ADDENDUM #2
 02/22/2018

A NEW REMODEL PROJECT FOR:
SHERWOOD HIGH SCHOOL

SHEET NO:	FP-1.1
	1 OF 1

1 FIRE PROTECTION FLOOR PLAN
 FP1.1 SCALE: NOT TO SCALE

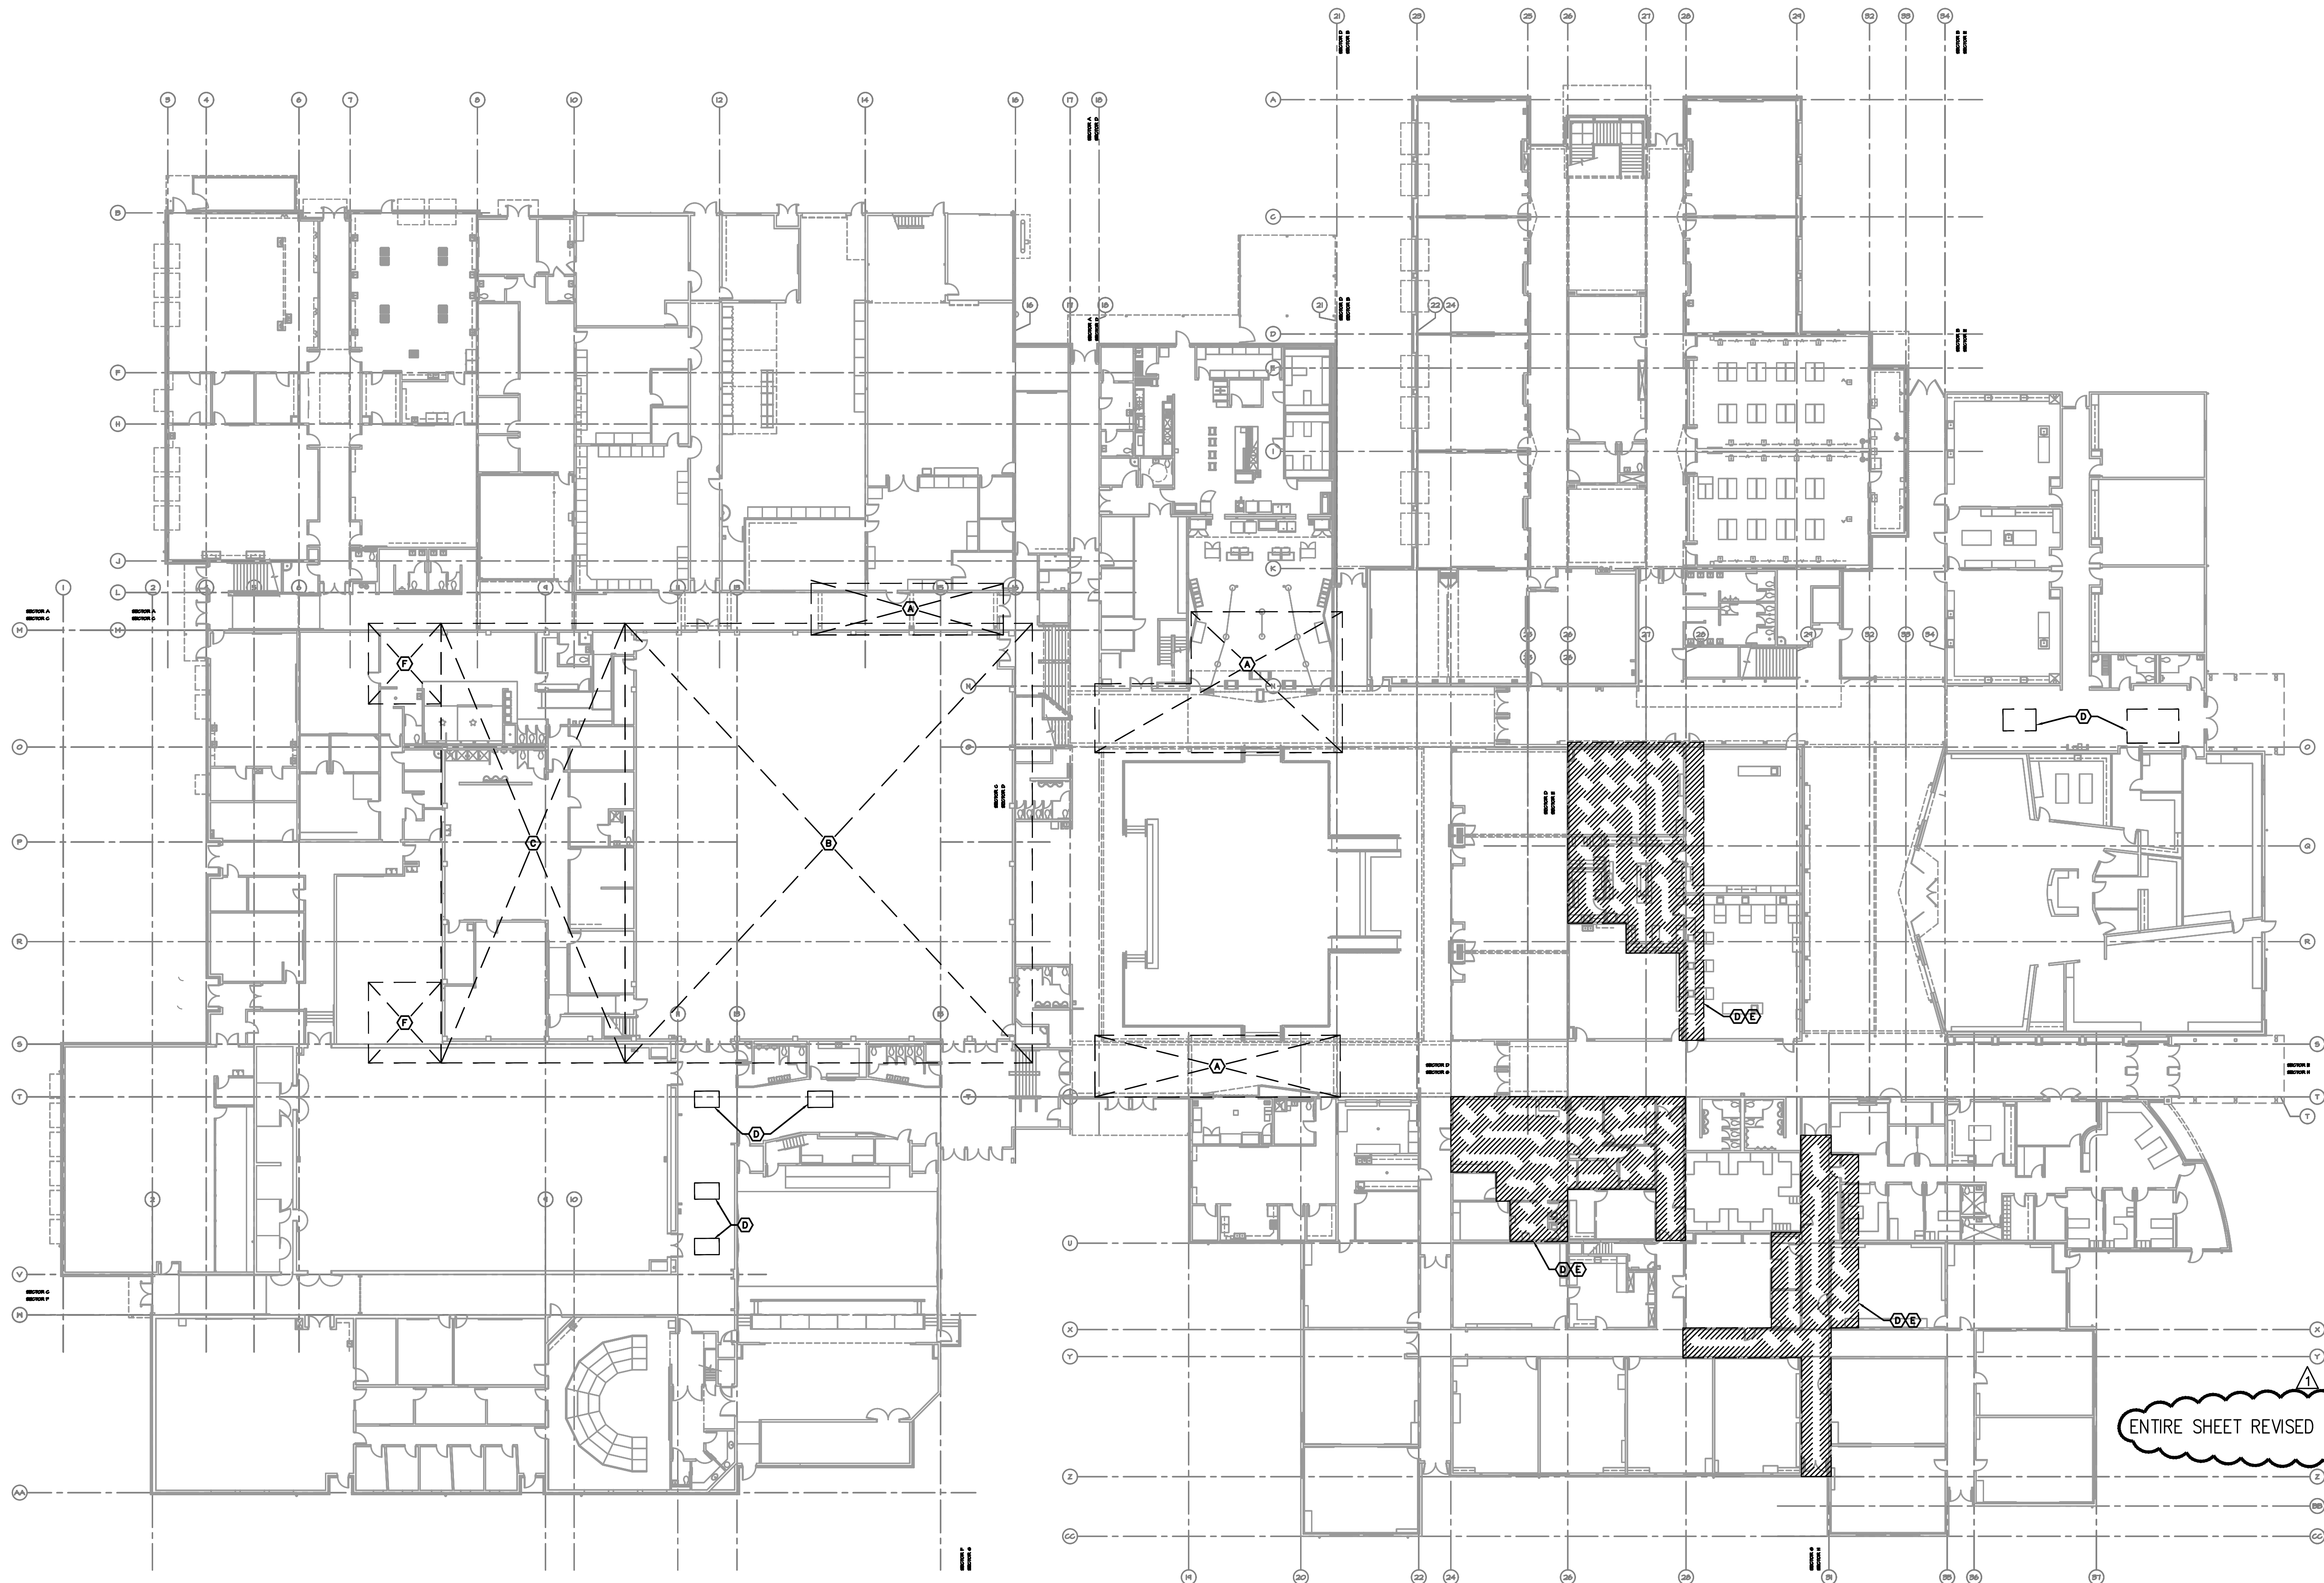
ENTIRE SHEET REVISED PER ADDENDUM #2

- (A) - ALTER SPRINKLER LINES EXPOSED IN MECHANICAL ROOMS ABOVE THIS AREA DUE TO NEW DUCTWORK AND EQUIPMENT.
- (B) - EXISTING 6" FIRE SPRINKLER SYSTEM INSTALLED IN 1971. PROVIDE SEISMIC BRACING OF ALL PIPES PER CURRENT NFPA-13 & OSSC CHAPTER 16 REQUIREMENTS.
- (C) - EXISTING UPPER GYM & MECHANICAL MEZZANINE SPRINKLER SYSTEM INSTALLED IN 1971. PROVIDE SEISMIC BRACING OF ALL PIPES PER CURRENT NFPA-13 & OSSC CHAPTER 16 REQUIREMENTS.
- (D) - ALTER SPRINKLER LINES ABOVE CEILING TO MAKE WAY FOR NEW DUCTWORK.
- (E) - REMOVE EXISTING SPRINKLER SYSTEM FROM THIS AREA. NEW LINES TO BE INSTALLED ABOVE NEW CEILING.
- (F) - ALTER SPRINKLER LINES EXPOSED IN 2ND FLOOR DANCE AREA DUE TO NEW DUCTWORK AND EQUIPMENT.
